Item Name: Crosstube Turning Detail

DART AEROSPACE LTD	Work Order:	96764
Description: Crosstube Assembly	Part Number:	D206-667-243
Inspection Dwg: D206-667-243 Rev: C		Page 1 of 2

DRAWING NO. D206-667-243	TITLE CROSSTUBE ASS'Y (206L HIGH AFT)	REV. C	DART AEROSPACE LTD ENGINEERING ORDER		D.E.O. NO. D206-667-243-C-1	SHEET NO. SHEET 1 OF 1	SCALE NTS
DRAWN <i>q</i>	CHECKED <i>ASS</i>	MFG. APPR. <i>RB</i>	APPROVED <i>MP</i>		DE APPR. <i>#</i>		
DATE 11.07.15	DATE 11.07.20	DATE 11.07.21	DATE 11/07/21		DATE 11.07.21

REPLACE MAGNOBOND WITH PROSEAL.

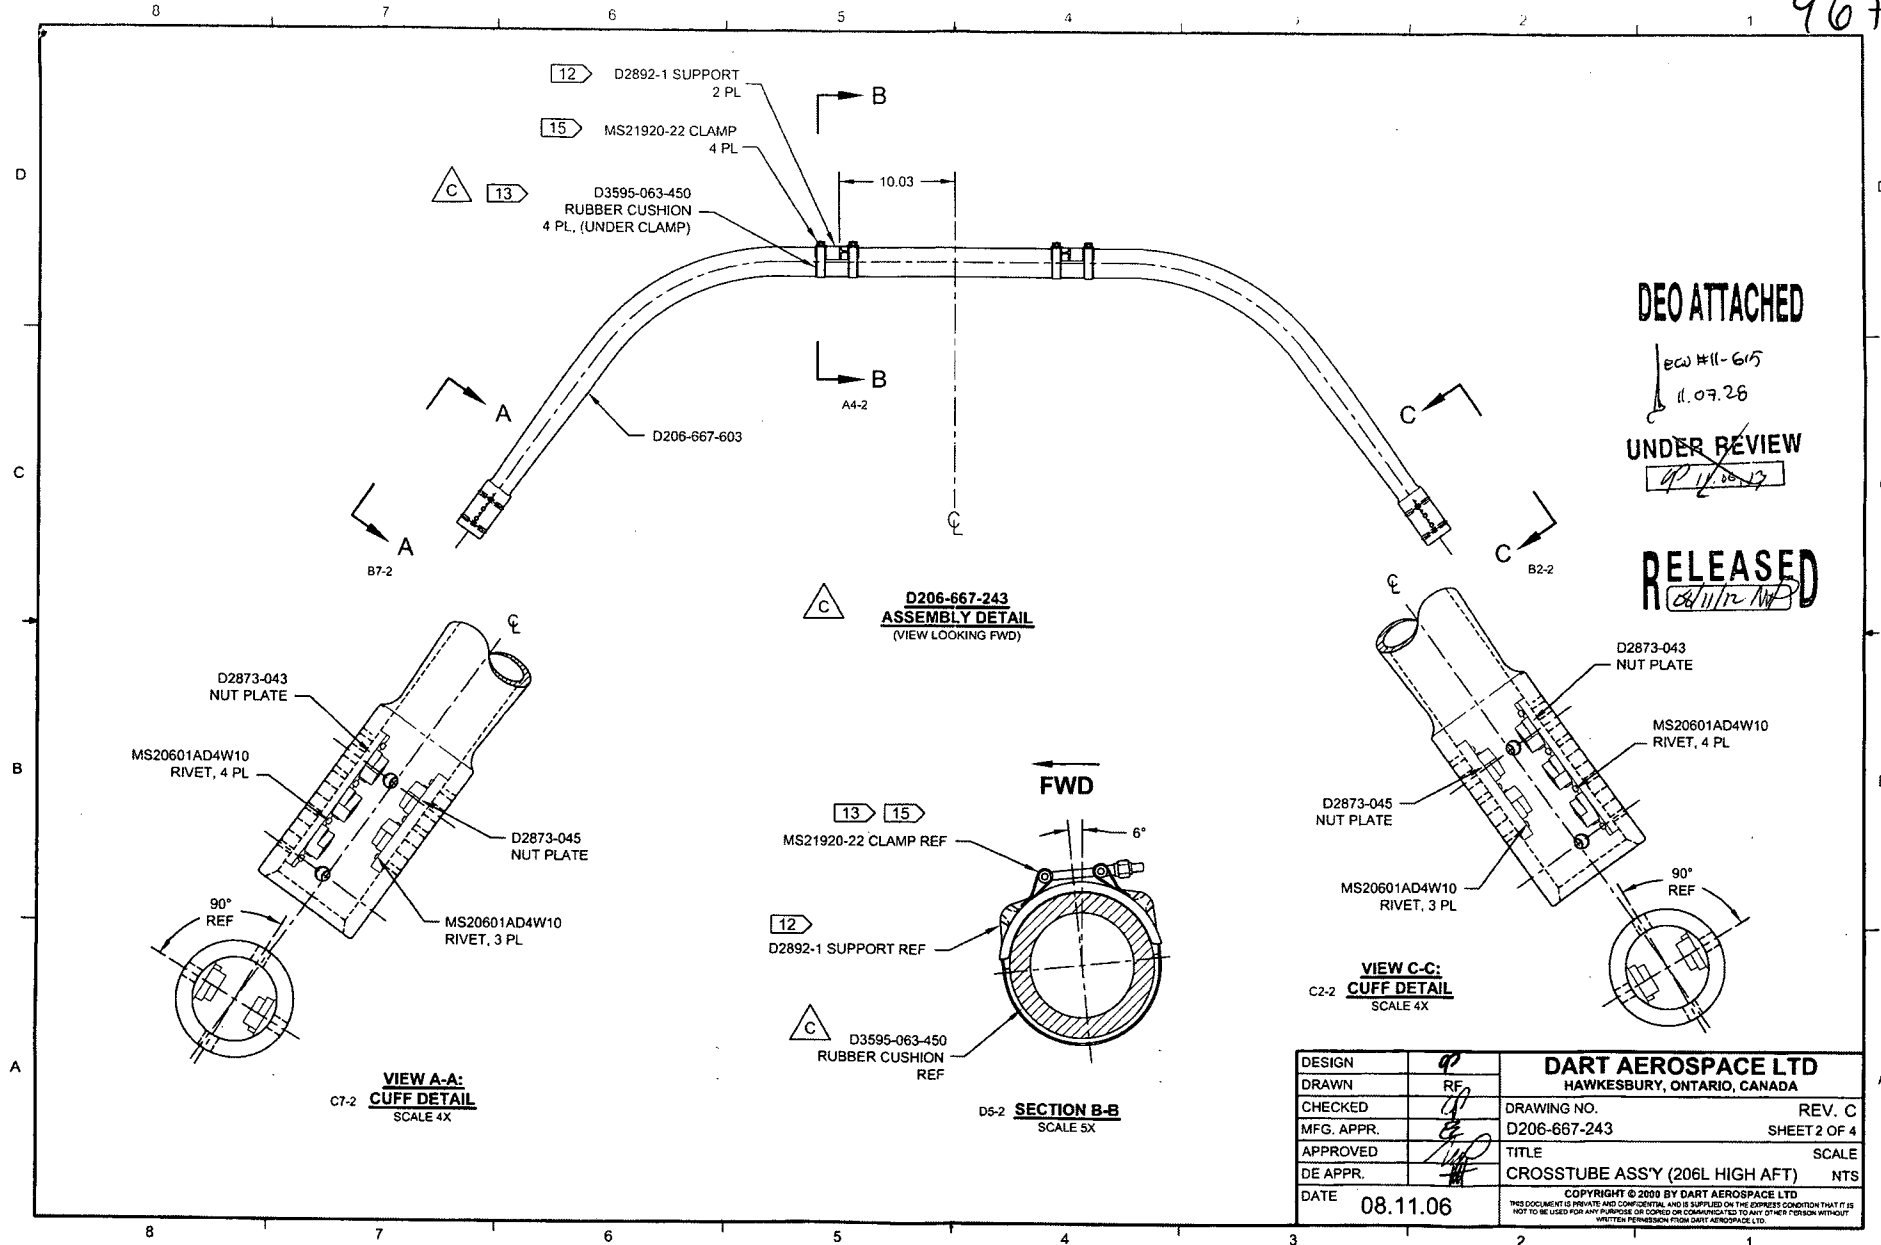
PURPOSE:

NOTE 12 & 15, SHEET 1 IS AMENDED AS FOLLOWS:

- 12) TO INSTALL D2892-1 SUPPORT: ABRABE MATING SURFACE OF SUPPORT AND CROSSTUBE WITH 180-GRIT SANDPAPER AND REMOVE RESIDUE WITH MEK (OR EQUIVALENT). APPLY A 0.04" TO 0.07" THICK LAYER OF PROSEAL 890 CLASS B-2 (OR AMS-S-8802 CLASS B-2) SEALANT TO MATING SURFACE OF SUPPORT.
- 15) TORQUE CLAMPS 80 TO 100 IN-LB. ENSURE AT LEAST 1.5 THREADS SHOWING IN SAFETY AND THAT NUT HAS NOT BOTTOMED-OUT AFTER TORQUING. **PRIOR TO PACKAGING, RE-CHECK TORQUE ON CLAMPS AFTER PROSEAL 890 SEALANT HAS CURED FOR 72 HOURS.**

- 12) INSTALL D2892-1 SUPPORT USING 0.03" TO 0.06" THICK LAYER OF MAGNOBOND 6398 PER QSI 015. LET CURE FOR 12 HOURS AFTER INSTALLATION AND PRIOR TO PACKAGING.
- 15) TORQUE CLAMPS 80 TO 100 IN-LB. ENSURE AT LEAST 1.5 THREADS SHOWING IN SAFETY AND THAT NUT HAS NOT BOTTOMED-OUT AFTER TORQUING.
